Government of Madras.

Marine DEPARTMENT.

G.O. No.	373	Press ~~Mis.~~
Dated	16. 9.	1857

Fort Saint George, Marine Consultation, 22nd September 1857.

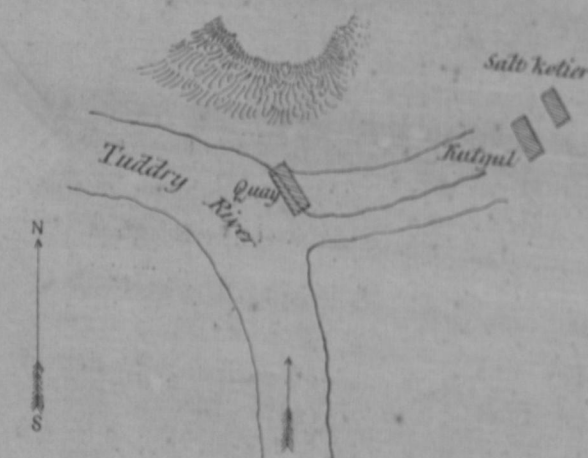
Para. 154. Kutgul is a small shipping place on the Tuddry river, which is capable of considerable improvement, as also is the navigation of the river both above and below, it is 18 miles from the port of Tuddry where large cotton screws are being erected by Mr. Brice, a merchant of talent and enterprise.

3. The Right Honorable the Governor calls attention to the necessity of improving this station, and I much regret, that it is at present out of my power to fully do justice to this important entrepot.

A sketch of the river at this point [from memory] is noted in the margin, with the proposed site of the Quay.

I am at present unable to detail any Officer to prepare a survey and sections of the river at this point, and the Overseer in charge is unable to survey; hence the matter is at present in abeyance, but at the first opportunity, I shall provide myself with Plans and Sections, and design a Quay for this locality, as it is a place of very great importance. No report of the trade at this point is obtainable by me, or it would be inserted in the margin.
